# Access Compliance Report

## Public Rights-of-Way

Intersection ID: 3253	Main Street: SUTTONVIEW_DR	Cross Street: SHADOW_PINE_DR	Location: SW
ADA ID: 0AB1FB56483E	Ramp Type: Perp	Initial Pass/Fail: Pass	Overall Compliance: No
Severity Score: 2.5			
Codes/Mitigation Info/Possible Solution		Field Measurements/Component Compliance

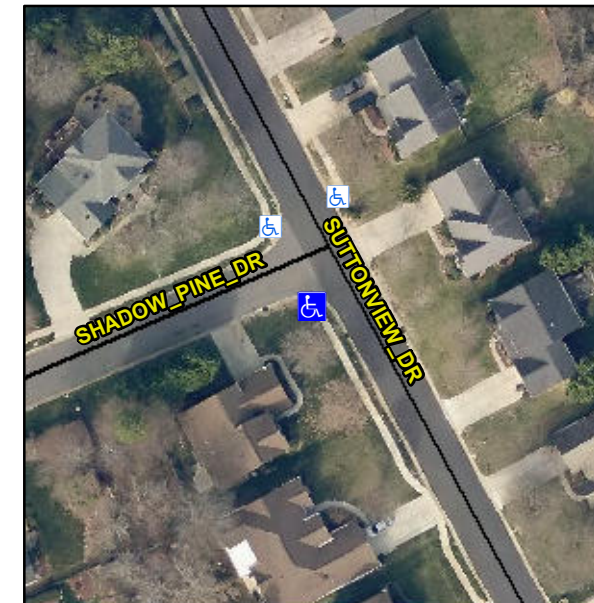
**R304.2.1, R304.2.2-Perp, R304.3.2-Para, R305.1.4, R305.2**

Compliance	Description	Data	Compliance	Description	Data
N/A	Ramp Length (in)	48.0	Yes	Ramp Slope (%)	5.1
Yes	Ramp Width (in)	50.0	Yes	Ramp XSlope (%)	1.4
N/A	Flare Type LT	Sloped	N/A	Flare Type RT	N/A
N/A	Flare Slope LT (%)	3.3	N/A	Flare Slope RT (%)	5.2
N/A	Flare Traversable LT?	No	N/A	Flare Traversable RT?	No
No	Landing Length (in)	47.0	Yes	DWS Provided?	Yes
Yes	Landing Width (in)	70.0	Yes	DWS Contrast?	Yes
No	Landing Slope (%)	6.0	Yes	DWS Length (in)	25.5
Yes	Landing X Slope (%)	1.2	No	DWS Full Width?	No
N/A	Landing Curb? (Y/N)	No	No	DWS Offset (in)	3.0
N/A	Shared Landing?	No			
Yes	Gutter Ponding?	No	Yes	Gutter Slope (%)	2.1
Yes	Gutter Lip Ht (in)	0.0	Yes	Gutter X Slope (%)	0.1
N/A	Painted X Walk1?	No	N/A	Painted X Walk2?	N/A
	X Walk 1 Direction	To N		X Walk 2 Direction	N/A
N/A	X Walk 1 Width (in)	N/A	N/A	X Walk 2 Width (in)	N/A
	X Walk 1 Slope (%)	1.3		X Walk 2 Slope (%)	N/A
	X Walk 1 X Slope (%)	0.4		X Walk 2 X Slope (%)	N/A

N/A	Ramp inside XWalk1?	N/A	N/A	Ramp inside XWalk2?	N/A
	Road Slope (%)	N/A	N/A	Clear Space?	Yes
	Road X Slope (%)	N/A	N/A	Clear Space to XWalk (in)	N/A
Yes	Any Obstructions?	No	Yes	Storm Grate/Utility Hazard?	No
	Obstruction Type			Storm Grate/Utility Type	
		N/A			N/A
			Yes	Surface Condition? (G/P)	Good

**Remove & Replace Entire Ramp.**
